Agenda item: 650-588

Title: Clarification of Figure 3-5

Purpose: To determine if it is appropriate to add flanged nozzles to Figure 3-5.

Figure 3-5—Shell Nozzles (continued)

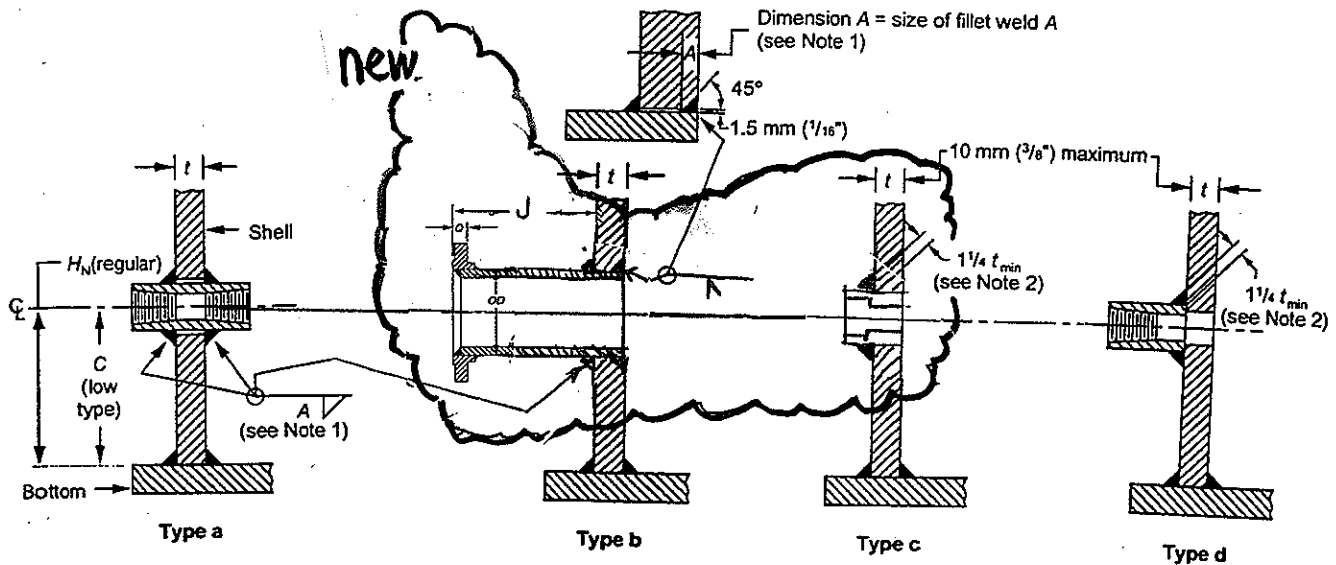
Rationale: Connection details in Panel 4 are acceptable for small diameter pipe. Footnote f under Table 3-6 states that flanged nozzles under 3"Ø do not need repads.

It is not clear what is acceptable for flanged nozzles wall thickness under 1.5"Ø. Language can be added to state, as a footnote under panel 4 either

- a) that nozzle neck thickness must be 0.200" or thicker [or other limit]
or
b) that flanged nozzles under 1.5"Ø or not allowed.

Proposal: Modify Figure 3.5 per attached figure.

1. Figure 3-5 revised to show one of the figures as a nozzle neck and one with a socket weld as clarification of the intent.
2. The Title of Figure 3-5 (on page 3-17) should be "Couplings and Flanged Fittings, NPS 3/4 Through NPS 2 ".
3. The header for the lower part of Table 3-6 is " Couplings" instead of "Threaded Fittings"
4. Where threaded nozzles or threaded fittings are referenced (example - notes f and g to table 3-6) change to couplings.

THREADED-TYPE SHELL NOZZLES, NPS 1/4 THROUGH NPS 2
COUPLINGS AND FLANGED FITTINGS, NPS 1/4 THROUGH NPS 2 (SEE NOTE 3)

1. See Table 3-7, Column 6.
2. t_{min} shall be 19 mm (3/4 in.) or the thickness of either part joined by the fillet weld, whichever is less.
3. The construction details apply to unreinforced threaded, non-threaded, and flanged nozzles.

NEW

NEW
